<b>REFERENCE:</b>	<b>TSB:</b> 08-028-25 REV. B <b>GROUP:</b> 08 - Electrical	<b>Date:</b>	April 29, 2025	<b>REVISION:</b>	08-028-25 REV. A
<b>VEHICLES AFFECTED:</b>	<b>2025 (LB) Dodge Charger</b> <b>This bulletin applies to vehicles built on or before <b>**April 03, 2025 (MDH 0403XX)</b> equipped with 400V G2500 FR/RR Elec Drive Motors (Sales Code ELD).</b>			<b>MARKET APPLICABILITY:</b>	
				<input checked="" type="checkbox"/> NA	<input checked="" type="checkbox"/> MEA
				<input checked="" type="checkbox"/> SA	<input checked="" type="checkbox"/> IAP
				<input checked="" type="checkbox"/> EE	<input checked="" type="checkbox"/> CH
<b>CUSTOMER SYMPTOM:</b>	<p><b>Customers may experience a Malfunction Indicator Lamp (MIL) illumination and the vehicle may exhibit/set one or more of the following Diagnostic Trouble Codes (DTCs):</b></p> <ul style="list-style-type: none"> <li>● C10F8-00 - Left Front Wheel Hub Disconnect Actuator Position Sensor Circuit Range/Performance.</li> <li>● C10F9-00 - Right Front Wheel Hub Disconnect Actuator Position Sensor Circuit Range/Performance.</li> <li>● P061B-00 - Internal Control Module Torque Calculation Performance.</li> </ul> <p><b>Customers may al

**Fig. 3**  
#38 AGSM Fuse Location

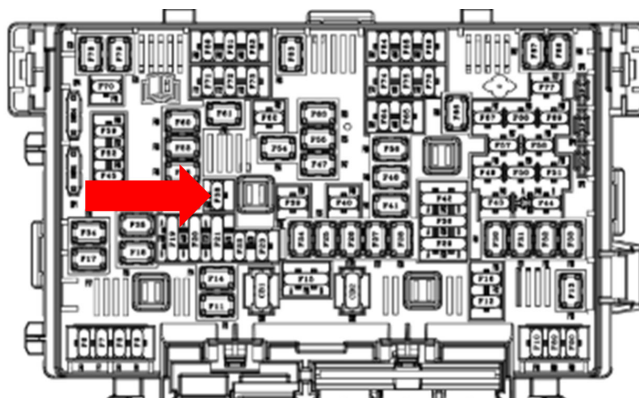
6. Remove the PDC cover, locate and remove the #38 AGSM fuse [Fig. 3](#).\*\*

24. \*\*Install the #38 AGSM fuse [Fig. 3](#) and the PDC cover [Fig. 2](#).
25. Position the rear carpet in place.\*\*
26. Connect the cooling fan wire harness connector [Fig. 1](#).
27. Install the front storage bin. Refer to the detailed service procedures available in DealerCONNECT/ ServiceLibrary under: Service Info> 23 - Body / Exterior / Bin, Storage / Installation.
28. Clear any DTCs that may have been set in any modules due to reprogramming. The wiTECH application will automatically present all DTCs after the flash and allow them to be cleared.
